AGENDA FOR REGULAR MEETING VILLAGE OF TINLEY PARK PLAN COMMISSION

PLAN COMMISSION STAFF REPORT

7451 183rd Street

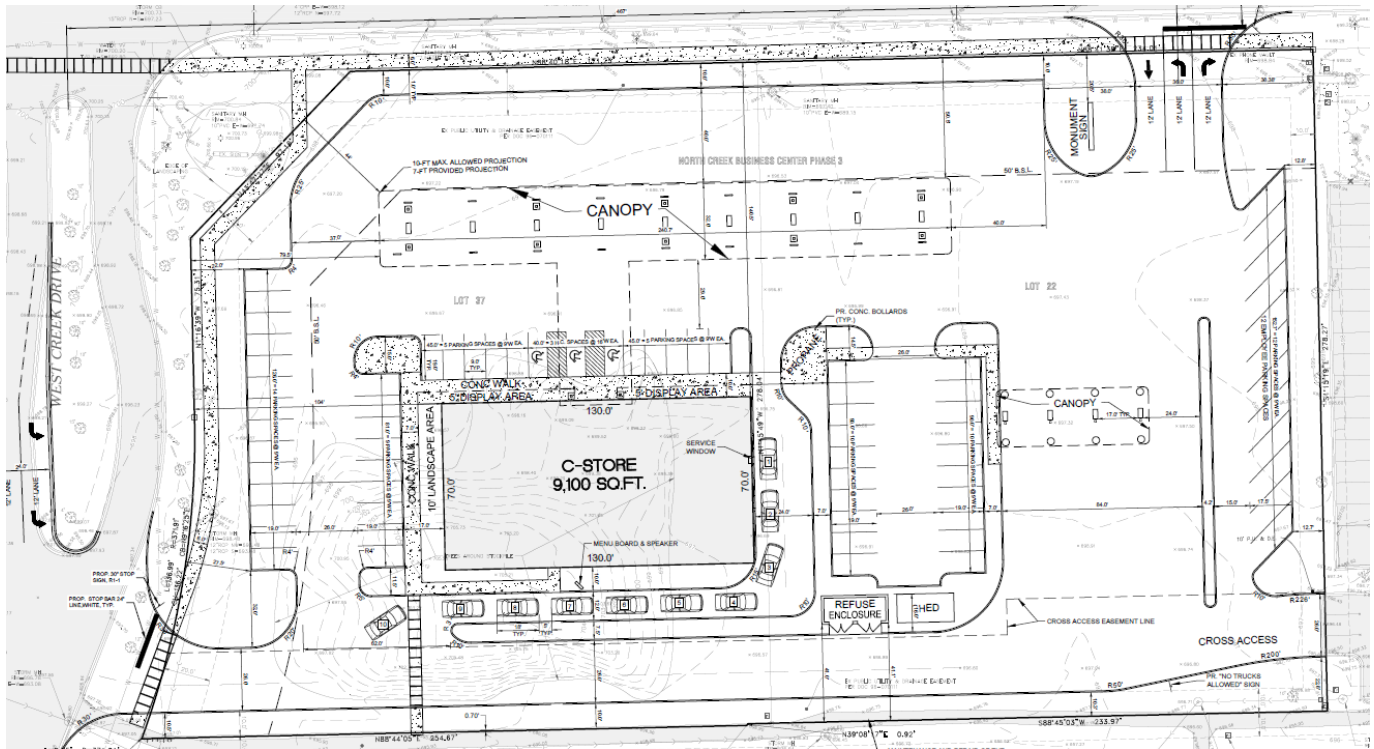
The access on 183rd Street is currently proposed as a full-access. Staff does not expect that the full-access design will receive approval from Cook County Department of Transportation (CCDOT) or the Village Engineer due to safety concerns with the proximity to two other full access points. Having full access points too close together on a heavily traveled roadway can create dangerous and competing vehicles turning movements. Additionally, it is expected that a traffic signal will be installed at North Creek Drive in the future when the mental health center site is redeveloped. The traffic signal makes a full-access point even more problematic. With existing full access points already established (North Creek Drive and West Creek Drive), it is recommended a limited (right-in/right-out) access be pursued on 183rd Street. The site circulation (including truck and emergency vehicles) was designed to work even if this access point is reduced to right-in/right-out only, so no site changes will be needed. Staff recommends the plans be revised accordingly.

Open Item #1: Discuss the full access proposed on 183rd Street. Staff recommends the plans be revised to show only a right-in/right-out limited access to avoid potential traffic safety concerns.

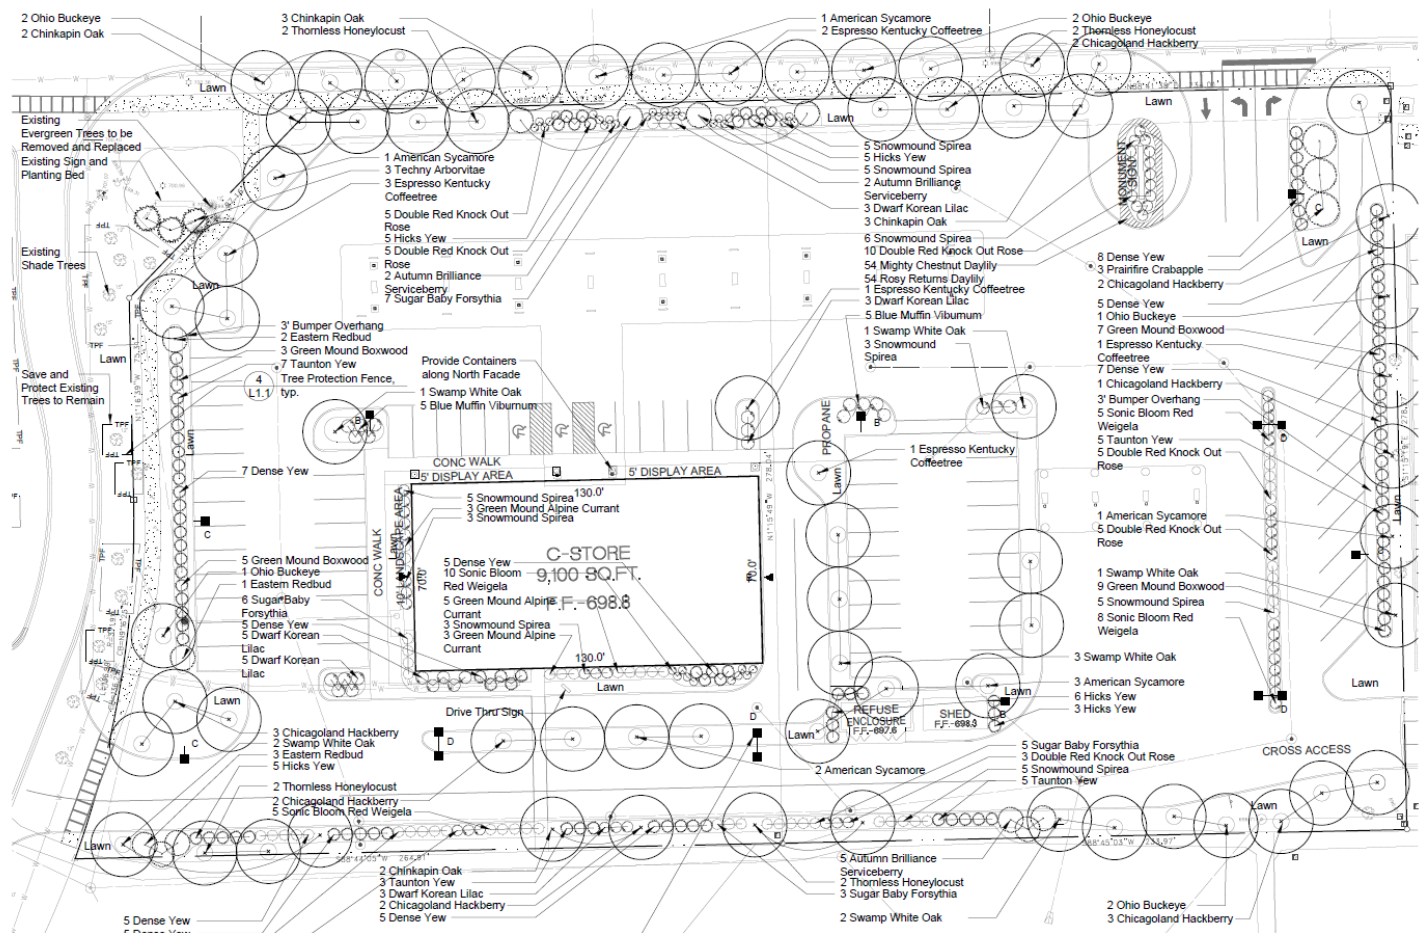
The proposed Landscape Plan has been reviewed by the Village's Landscape Architect and finds it to be in general conformance with the Village's Landscape Ordinance with a few exceptions. The proposal requests a waiver from the north bufferyard landscaping totals due to a substantial number of parkway trees already proposed to be installed. The petitioner has indicated that additional landscaping along the 183rd Street frontage, especially trees, will block most visibility to the site, which is required to run the business successfully and for traffic visibility reasons. The Village's consultant supports the bufferyard and recognizes the area functions appropriately with the addition of parkway trees. However, there is an ability to add additional shrubs within this frontage. If additional pavement area exists, widening the bufferyard can also reduce the amount of landscaping required. The east bufferyard area has the ability to add additional landscaping and a tree in an end island that has been left as lawn. Staff recommends these few revisions be made to reduce the landscape waivers on the North and East bufferyards where possible.

The second waiver being requested is in regards to the interior parking lot landscaping. The petitioner has worked to offset these deficiencies by meeting the high density and size of landscaping required throughout the site perimeter. The landscape code is not particularly easy to comply with on a gas station property in regards to interior parking lot landscaping. The fueling area needs to remain free from obstructions and allow room for vehicle and truck movement throughout the site. Landscaping pots can be added but these are often hard to maintain hearty landscaping in throughout the year.

The petitioner met the majority of the landscape code, yet these few deficiencies remain due to site constraints. The proposed landscaping is similar in style and design with surrounding area properties, such as Hamada, Comfort Inn & Suites, Sleep Inn, and the recently approved Holiday Inn. Below is a list of the landscaping deficiencies in the proposed plan. The species and variety of plantings are expected to increase the appeal of the property and overall area.

Open Item #2: Discuss the proposed landscape plan and requested Landscape Ordinance waivers. Discuss staff's recommendations and the ability to comply to a greater degree with the north and east bufferyard landscaping requirements.

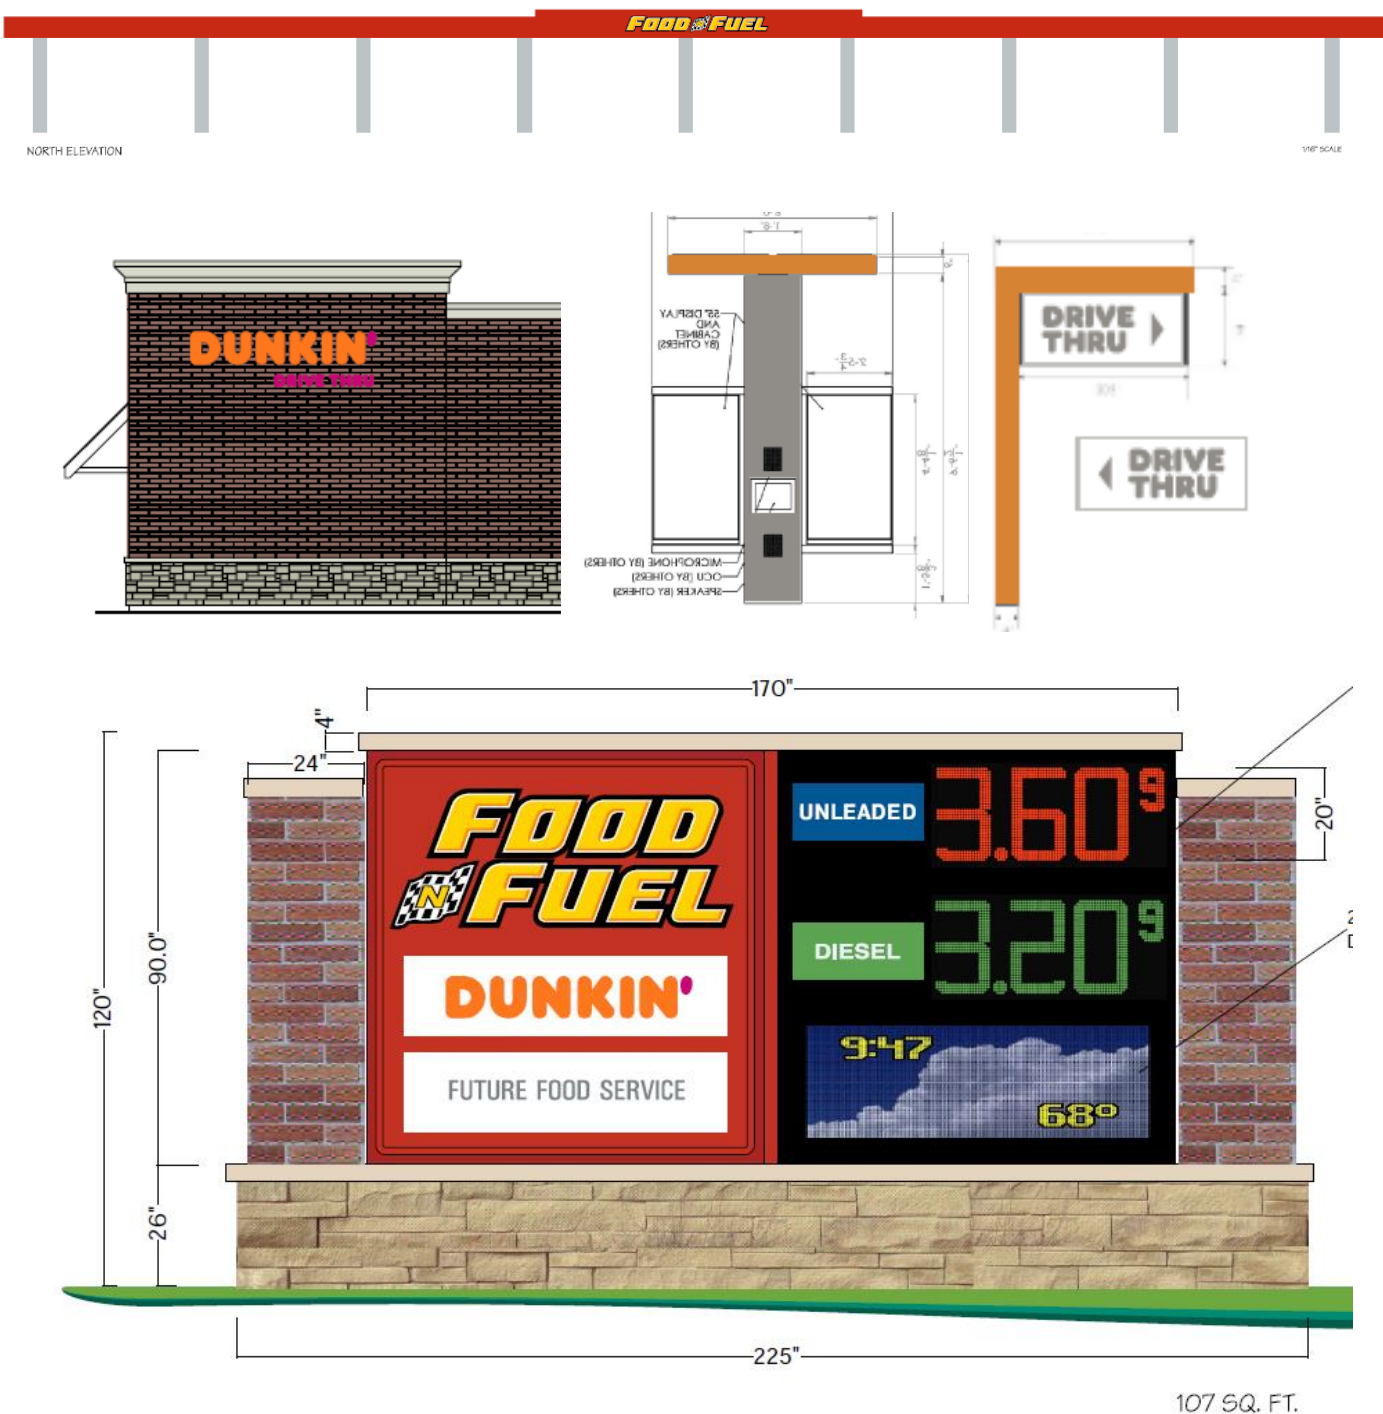
The renderings shown in the staff report and packet are from the Petitioner's original submittal and revisions based on staff review comments. These renderings were unable to be revised in time for the workshop meeting, but will be updated prior to the public hearing. Changes include revisions to the proposed signage, landscaping, adding sidewalks, and additional front facade windows.

Open Item #4: Submit revised renderings based on prior architectural, signage, and site revisions.
